[Docket No. 96-NM-75-AD; Amendment 39-9581; AD 96-09-07]

#### Airworthiness Directives; Boeing Model 757 Series Airplanes Equipped With Moog Spoiler Actuators

**ACTION:** Final rule; request for comments.

## 757 SPOILER ACTUATOR INSTALLATION

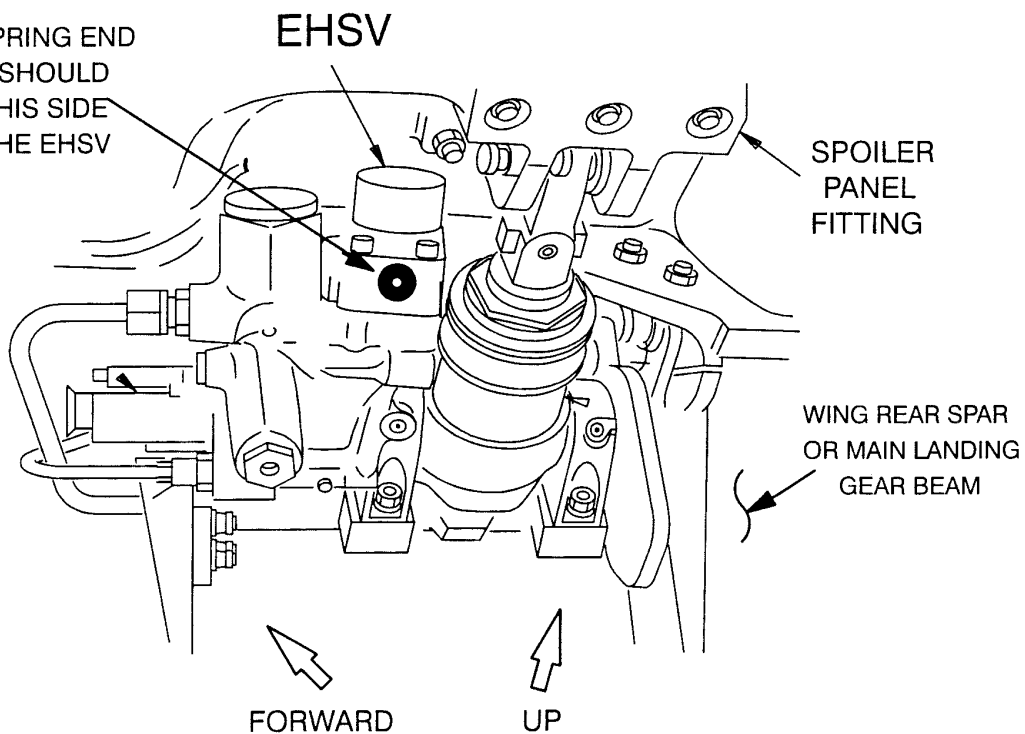
Note 2: To be correctly positioned, the second stage bias spring cap assembly should

be on the upper or forward side of the EHSV assembly. Appendix 1 of this AD provides a visual representation of the correct positioning of the EHSV assembly.

SECOND STAGE SPRING END  
CAP PROTRUSION SHOULD  
NOT EXTEND ON THIS SIDE  
(UNDERSIDE) OF THE EHSV

(2) If the second stage bias spring cap assembly is on the aft or lower side of the EHSV assembly, prior to further flight, replace the EHSV, having Abex part number 72196, with a serviceable unit in accordance with the airplane maintenance manual.
